BILL NO. 2006-77

AN ORDINANCE TO ADOPT AS THE CITY'S BUILDING CODE THE 2006 EDITIONS OF THE INTERNATIONAL BUILDING CODE AND INTERNATIONAL RESIDENTIAL CODE, TOGETHER WITH AMENDMENTS THERETO, AND TO PROVIDE FOR OTHER RELATED MATTERS.

SOUTHERN NEVADA AMENDMENTS

2006 INTERNATIONAL BUILDING CODE

FIGURE R606.11(1) ANCHORAGE REQUIREMENTS FOR MASONRY WALLS LOCATED IN SEISMIC DESIGN CATEGORY A, B OR C AND WHERE WIND LOADS ARE LESS THAN 30 PSF

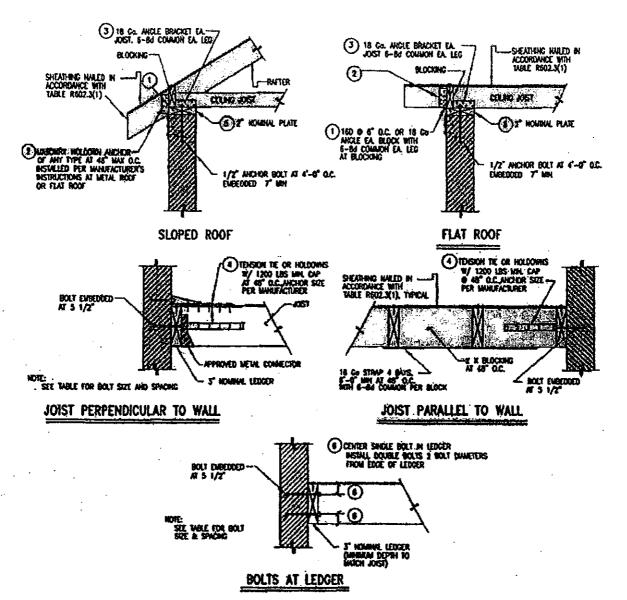
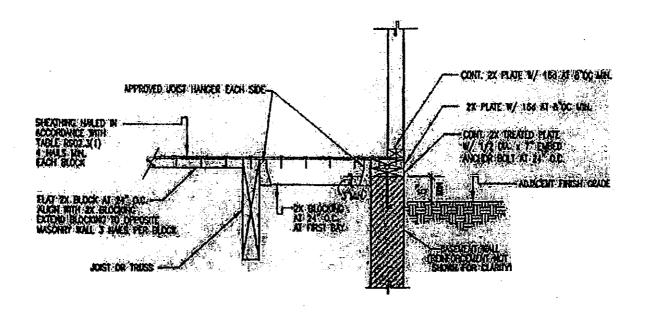
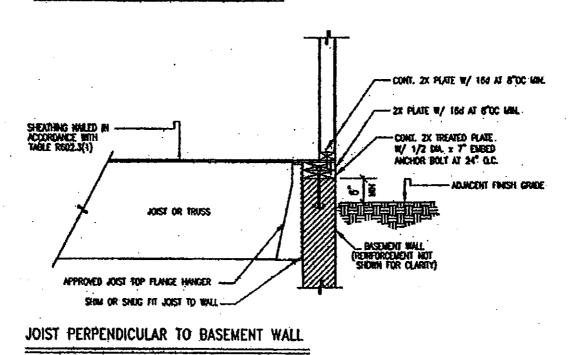
Figure R606.11(1) is deleted and replaced with a new Figure R606.11(1) to read as follows:

NOTE: WERE BOLTS ARE LOCATED IN HOLLOW. MASONRY, THE CELLS IN THE COURSES RECEIVING THE BOLT SHILL BE GROUTED SOLID. FOR St. 1 INCH = 25.4 Mg, 1 FOOF = 30.8Mg, 1 POURD PER SOURCE FOOF = 8.0478004Mg.

NOTE: WHERE BOLTS ARE LOCATED IN HOLLOW MASONBY, THE CELLS IN THE COURSES RECEIVING THE BOLT SIMIL BE GROUTED SOLID. FOR St. 1 INCH = 25.4 Maj, 1 Foot = 304.8Maj, 1 Pound per source foot = 0.0479Maj/m
